**PLANNED UNIT DEVELOPMENT
& SUBDIVISION STAFF REPORT****Date: November 21, 2013****DEVELOPMENT NAME**

Alba Place Subdivision

2529 River Forest Road
(South side of River Forest Road, 450' ± West of Alba Club Road)

CONTEMPLATED USE

REVISED SITE PLAN - 12/18/2013

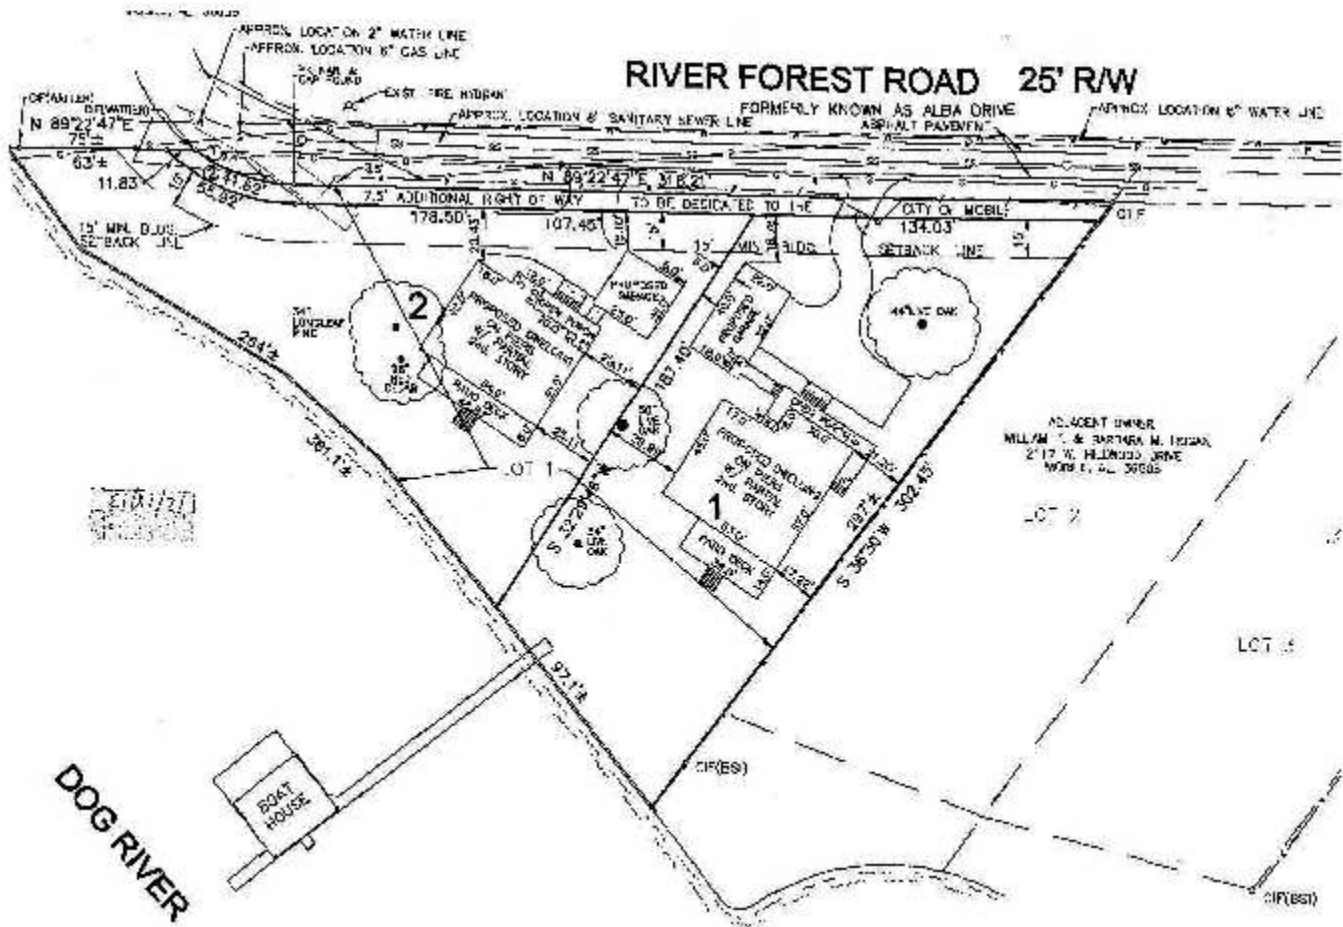
The applicant is requesting that the standard minimum front-yard setback be reduced to allow a 15' front-yard setback for the proposed Lots 1 and 2 and a 10' front-yard setback for the proposed Lot 3. It should also be noted that the proposed garages for the proposed Lot 1 and Lot 2 will be located only 5' from a shared lot line. The applicant should revise the PUD application to include a reduced side-yard setback.

It should be pointed out that the proposed Lot 1 and Lot 3 abut existing, residentially zoned lots. Typically, the side yard setback in PUDs is required to be at least 8' where the PUD abuts existing residential developments. Only the front-yard setback is depicted on the site plan and therefore, a side-yard setback of at least 8' should be required along the east boundary of the proposed Lot 1 and the west boundary of the proposed Lot 3. The Final Plat and PUD Site plan should be revised to reflect the required 8' setback and illustrate all other setbacks for the

It should be noted that access appears to be a concern due to the proximity of the proposed structures and proposed vehicle maneuverability areas. As proposed, the structures will be at least 10' from the applicant's proposed new right-of-way line. If additional dedication is required, there may only be a few feet of setback. It appears that the applicant may be over building the site.

Finally, it should be pointed out that there is an existing gate for the driveway of the proposed Lot 1 and a fence which runs along the existing property line along River Forest Road. The applicant should be aware that after the proposed 7.5' is dedicated to the City of Mobile, the existing fence and gate will be located within public right-of-way and, as a result, should be removed or relocated to the newly proposed property line. All other roadway and right-of-way improvements should comply with City of Mobile Engineering and Traffic Engineering requirements.

- 1) Dedication of 7.5' along River Forest Road, as proposed;*
- 2) Removal of the existing gate and fence along River Forest Road or relocation to the newly proposed property line after dedication is accounted for;*

- 3) Revision of the site plan to depict the lot size in square feet and acres;*
- 4) Revision of the site plan to depict the maximum site coverage (35%) allowed for both lots;*

- 5) Retention of all proposed setbacks on the site plan;*
- 6) Placement of a note on the site plan stating that each lot should be limited to one curb-cut each, with the size, design and location to be approved by Traffic Engineering and conform to AASHTO standards.;*

- 7) Placement of a note on the site plan stating: (Development of the site must comply with local, state and federal regulations regarding flood zones and wetlands.);*

- 8) Placement of a note on the site plan stating: (Development of the site must be undertaken in compliance with all local, state and Federal regulations regarding endangered, threatened or otherwise protected species.);*

13) Submission of a revised site plan prior to the signing of the Final Plat;
